DESCRIPTIVE REPORT

HYDROGRAPHIC SHEET FIELD No. U 2536

VERIFIER'S REPORT
HYDROGRAPHIC SURVEY
H-6256 (1936-7)

REVIEW OF HYDROGRAPHIC SURVEY NO. 6256 (1936-37) FIELD NO. U2536

H-6256 - 57

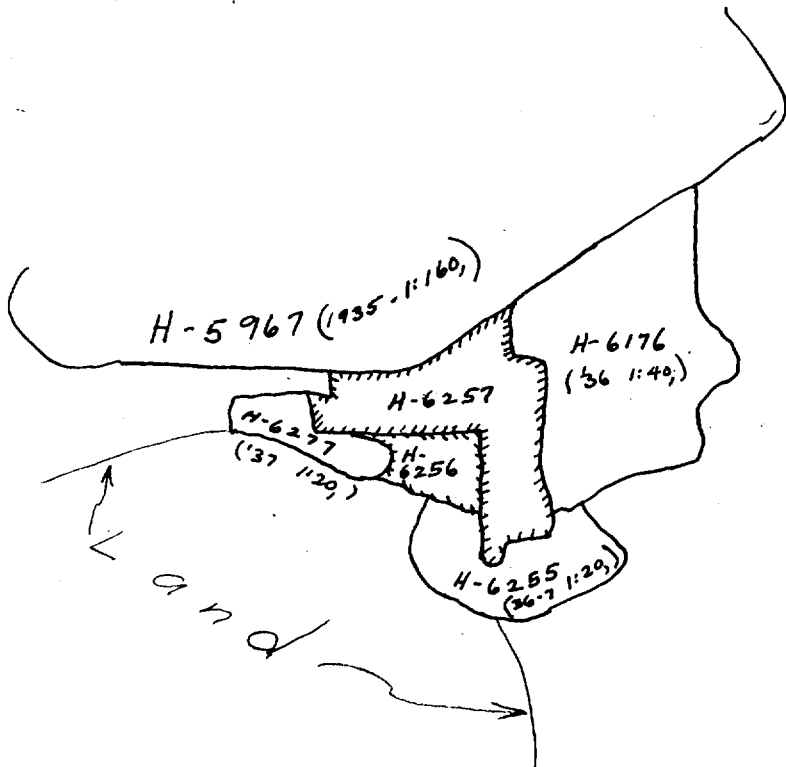
From note of H. F. S., the verifier began trying to adjust the line 120-121 B to a position 200 meters westward. As shown in pencil, position 121 B can be so moved by using the following fix:

The investigation was stopped when the verifier noticed the course 120-121 was 0° , thereby putting position 120 due south of 121, which is possible.

By order of Capt. Ellis the decision is left to the reviewer. As now, everything is plotted and inked as per records.

Original plotting done
the fix retained. ✓
